ADDENDUM

Project No.: 2501109 Addendum No: 02

Project: Daleville ES Classroom Addition Date: 07/25/2025

ADDENDUM NO. 02, to Drawings and Specifications dated July 10, 2025, for the Daleville ES Classroom Addition for the Daleville Community Schools; as prepared by ELEVATUS Architecture, 111 E. Wayne Street, Suite 555, Fort Wayne, IN 46802

Architectural Plans and Door Schedule

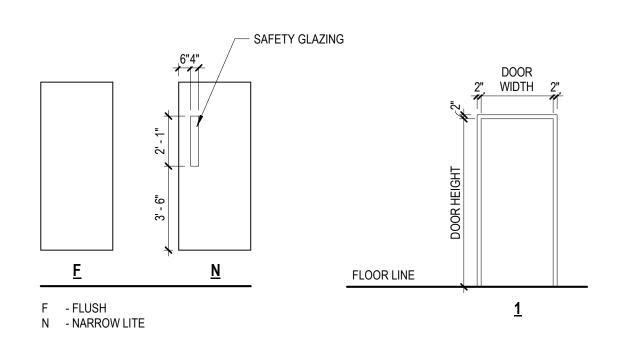
ITEM NO. 1.06 - DRAWING NO. A-111

A. Floor Plan Note 9.04 has been added to the plans for clarity.

9.02 EXISTING CLASSROOM AND STORAGE WALLS TO BE EXTENDED TO DECK. D.03 NEW GYPSLIN BOARD TO BE TRISTALLED, INTERIOR SUPE OF CLASSROOM. (9.04 PHASING NOTE: FRAME WALLS AND ADD GYPSUM BOARD ON CORRIDOR SIDE OF WALLS DURING T SCHOOL'S FALL BREAK IN OCTOBER. THIS IS TO PREVENT STUDENTS FROM POTENTIALLY INJURING THEMSELVES ON EXPOSED METAL STUDS. COORDINATE EXACT TIME AND DATE WITH OWNER AS TO WHEN YOU CAN BEGIN FRAMING AND WHEN IT MUST BE COMPLETED.
